Your Comment on the Sunfield project

1. Contact Details			
Please ensure that you have authority to comment on the application on behalf of those named on this form.			
Organisation name (if relevant)	Auckland Transport		
First name	Matthew		
Last name	Richards		
Postal address			
Home phone / Mobile phone	021 196 2810	Work phone	
Email (<i>a valid email address enables us to communicate efficiently with you</i>)	Matthew.richards@at.govt.nz

Beca has been engaged by Auckland Transport (AT) to provide a review of transportation matters in regard to a proposed mixed use development in Papakura, Auckland (the Sunfield application). The application is being progressed under the Fast Track Approvals Act (FTAA).

To:	Neil Stone, Principal Planner, Auckland Transport		
From:	Martin Peake, Director, Progressive Transport Solutions		
Project:	Fast Track Application - Sunfield Development Ardmore	Project No.	P23005/S021
Subject:	Comments on traffic engineering aspects of Fast Track Application		
Date:	29 July 2025

Figure 3: AT Designation 1836 as per AUP GeoMaps

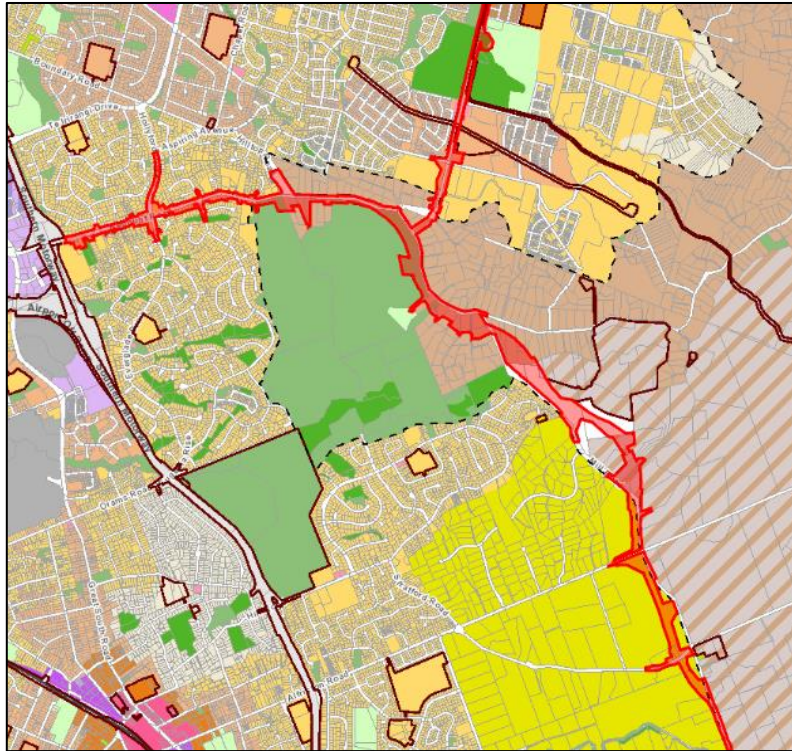
18. It is important that development does not proceed ahead of the upgrade/construction of the required transport network, which includes Mill Road Stage 2. Without Mill Road Stage 2, the development relies on the existing transport network, which, as discussed in the Beca Report – **Annexure 1**, results in significant network congestion that has not been identified as requiring mitigation by the applicant.

Figure 4 – Red - locations where road to road walkways should be provided. Yellow – locations where road to road access can be explored.

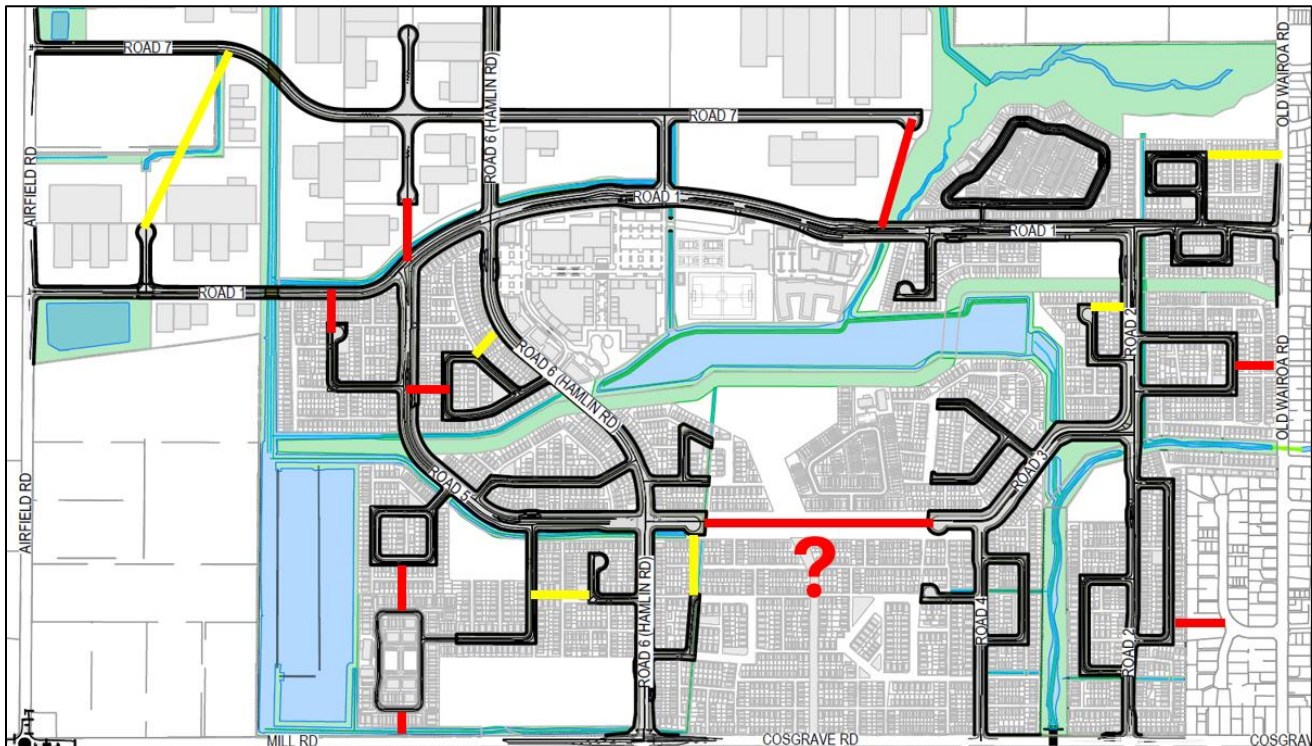
41. Road to road vested active modes connections internal to the site do not seem to be provided. The application drawings seem to indicate certain locations where these are possible, but these are not labelled. Figure 4 below shows in red the locations where it is considered that vested road to road accessways should be provided as part of the road network. This is considered a requirement of any large subdivision application^{9 10}, especially since the proposal has significantly reduced reliance on general vehicle travel. The proposal, as presented, does not indicate an efficiently connected neighbourhood, rather isolated residential blocks that do not allow for a connected and efficient layout of street patterns (legally).

42. In this regard 8m wide road to road accessways (as per AT's design standards) is recommended. The recommended road to road accessway locations are provided in the red lines on Figure 4 below. The connections offer significantly reduced travel time around the neighbourhood and key destinations. The yellow lines in Figure 4 below indicate where these connections could be beneficial, where the applicant can investigate providing a connection through an accessway or easement.

Figure 5 – frontage upgrades proposed in red, with yellow indicating AT's required upgrades areas.

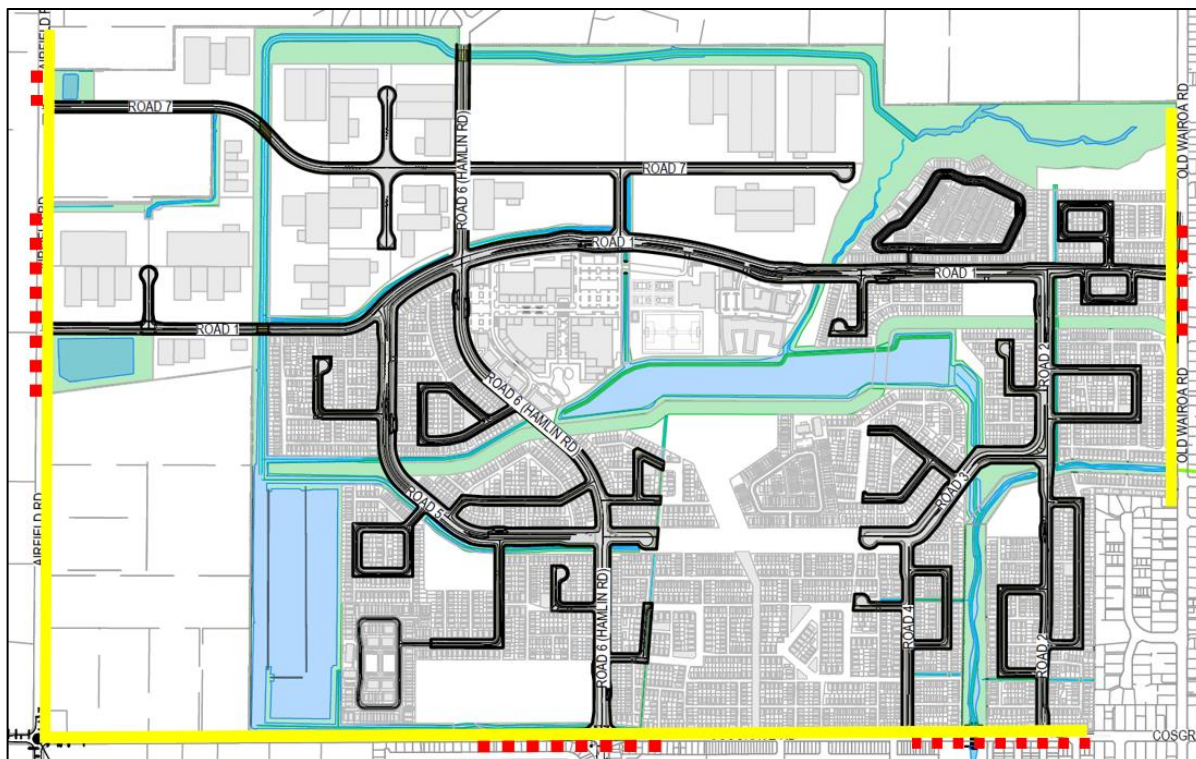
45. However, the Commute Transport Assessment section 7.1.2 only includes minor active modes upgrades to achieve this link, please refer to Figure 5 below. It is considered that the approach will not achieve the stated vision or reduce reliance on private vehicles. It is also noted that this proposal was not considered in any of AT's future plans, given that the majority of this site sits within rural land, and therefore AT's future cycling plans are not relevant to this proposal. The proposal must provide the active modes network that would have been in place by the time the site might have become development ready. In this regard, AT considers that the following active modes upgrades referenced in the below paragraphs need to be provided by the applicant.

47. It is unclear to what extent the applicant proposes to upgrade the site's frontage in terms of active mode upgrades. The applicant plans show limited sections of frontage upgrades – generally where the red dashed lines are presented in Figure 5 below. However, with the site not being earmarked for development, it is required that this site provide upgrades along the entire site 'block' to connect the site to the surrounding network, as this is required but unlikely to be provided by any other parties.

Figure 6 – applicant's suggested upgrades

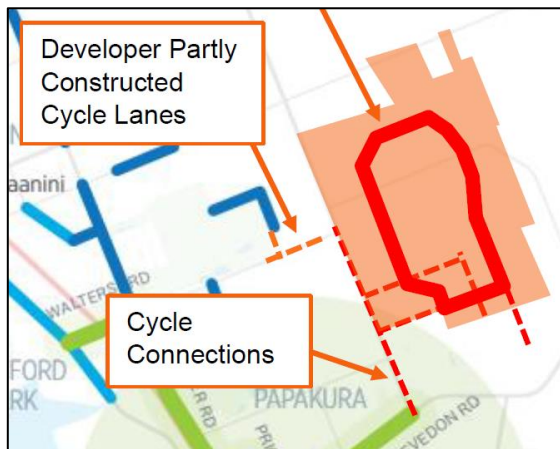
49. With regard to connecting the site to the wider road network from an active modes perspective, as mentioned above, the statement that the proposal attempts to align with AT's cycling strategy for the area is considered less relevant. Transport strategies for this area does not take into account that this (unanticipated) development will occur. Figure 6 below (Commute transport assessment figure 7-2) shows the proposed active modes links (dark orange dashed lines) provided by the applicant. In this regard, AT considers the following:

Figure 7 – AT recommended additional active modes upgrades

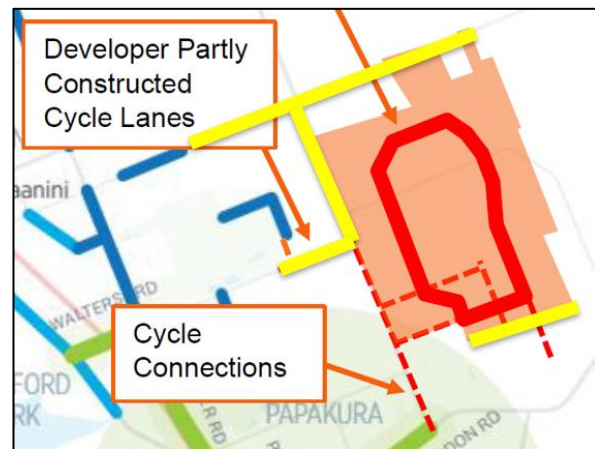
- The recommended upgrades also include active modes facilities on Mill Road, between Airfield Road and Walters Road.

f) The upgrades as per items d. and e. above are illustrated in yellow in Figure 7 below.

Popes Road/ Mill Road

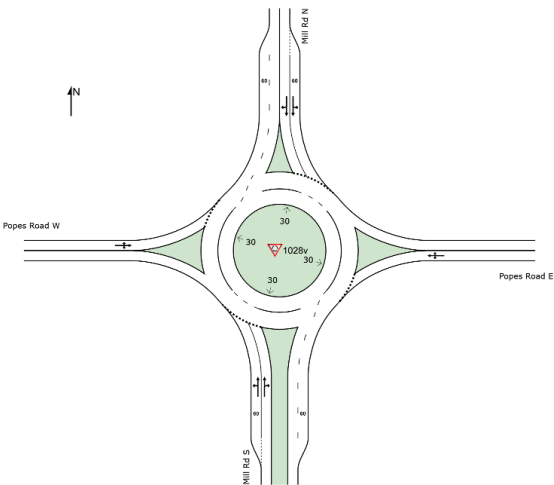
Comments : The roundabout has also been tested with a single lane along Mill Road but fails to accommodate the estimated 2041 volumes. Hence dual lanes for the roundabout have been considered with two lanes on the Mill Road. The 20 m roundabout diameter would deteriorate the LOS from B (current LOS for 30m diameter) to E. Note this may require land outside the current road reserve.

Cosgrave Road/ Walters Road/
Hamlin Road

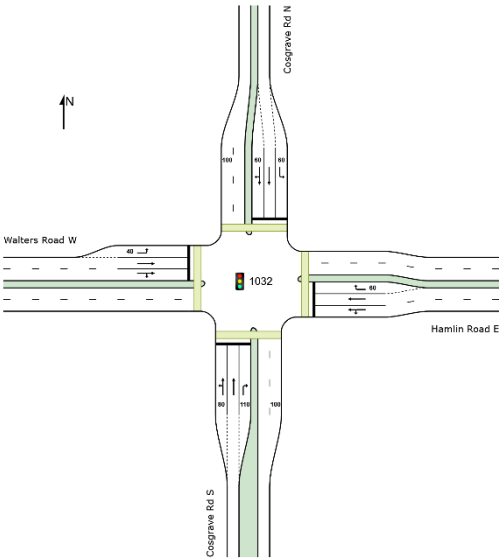
Comments : The lane arrangement has been altered along the North Arm and West Arm to accommodate the predicted volumes.

Mill Road / Alfriston Road

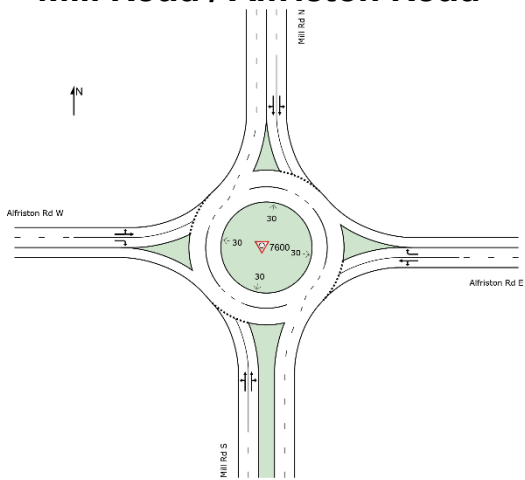
Comments : A dual lane roundabout have been considered for the analysis. The intersection fails in single lane configuration. Note this may require land outside the existing road reserve.

Pakaraka Drive / Old Wairoa Road / Road 1

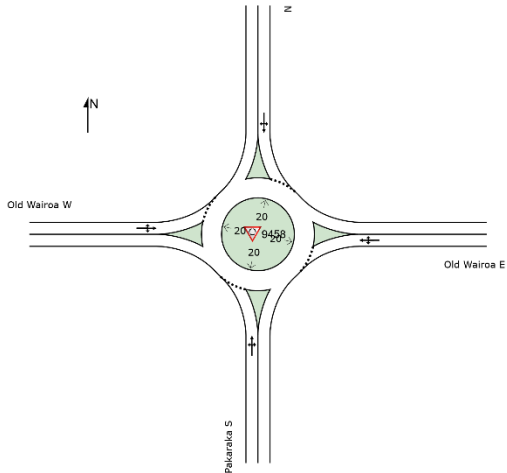
Comments : The ITA layout gives an LOS of F but performs with an acceptable LOS as a single lane roundabout. Ped/cycle crossings would need to be considered seperatley.

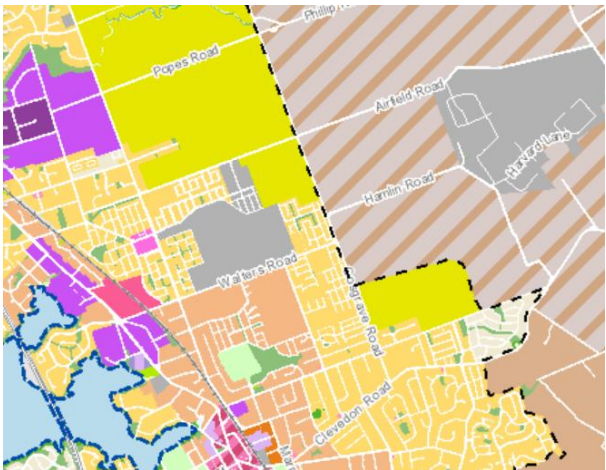
This will not achieve the vision as the necessary connections are not made. The proposed shared paths are also not suitable for the level of external commuter cycling anticipated (over 200 external cycle trips in the peak hour), which requires fully separated facilities.

The proposed network also does not recognise future growth in this area, for example the area shown in yellow as future urban zone below. There is a large area of future urban to the North of Airfield Road. Access to the Sunfiled site (employment zone for example) for these residents would be via Airfield Road which is currently devoid of walking and cycling facilities. An upgrade to Airfield Road is also warranted as part of this development to provide suitable access to/from surrounding areas including that not yet developed.

The development should provide separated cycle facilities along the length of Mill Road / Cosgrave Road between the northern extent of the development site and Old Wairoa Road, along the Old Wairoa Road frontage, and the Airfield Road frontage.

Figure 1 - Example of long pedestrian routes to access bus stops

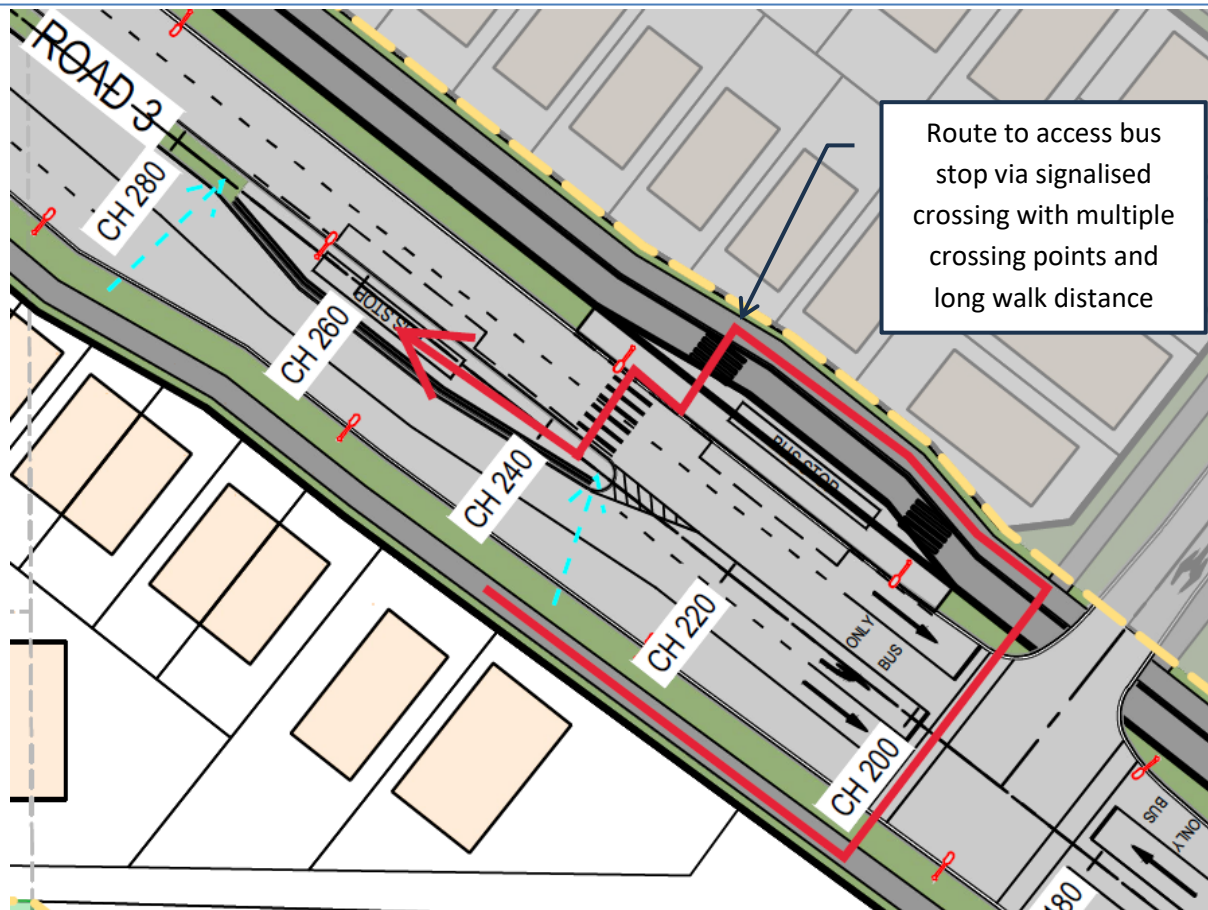
The bus stops have been designed in pairs and have pedestrian crossings (zebras) provided across the busway. This will provide access to the bus stops for pedestrians on the side of the road with the separated cycle path and footpath. However, for pedestrians on the opposite side of the road, in many cases the only facilities for pedestrians to access the bus stops is via neighbouring signalised intersections (refer to Figure 1 for an example). This would significantly increase the travel distance, travel time, and the number of times pedestrians would need to cross the road. This is likely to either be a deterrent for pedestrians to use the buses or to result in pedestrians crossing away from the signalised crossings. This will increase the risk of potential conflicts between pedestrians and vehicles. Consideration should be given to providing more direct and convenient crossing points to reach the bus stops from the side of the road opposite the bus way.

Figure 2 – Example Intersection of Issues Highlighted

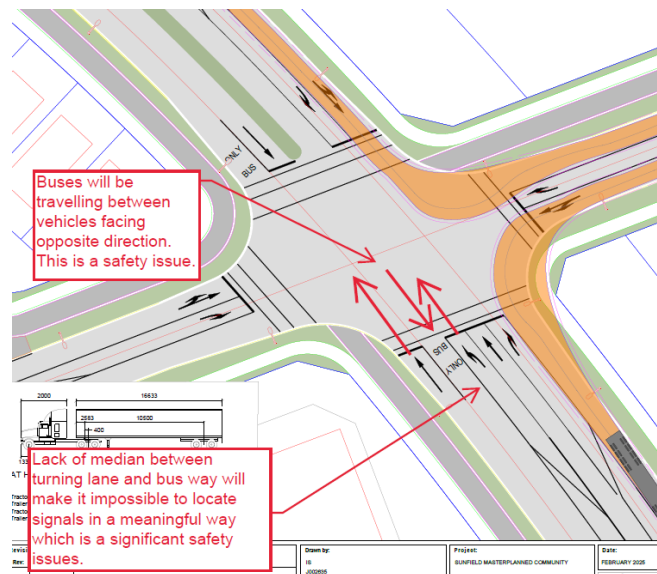
Many of the signalised intersections with the bus way remove the median island between the general traffic lanes and the bus way (refer to Figure 2 of an example intersection).

The median has been removed to form a left turn lane. This lane is required as the left turn movement needs to be held on a red signal whilst the through movements along the bus way and the general traffic lanes run on a green signal. However the removal of the median island will result in:
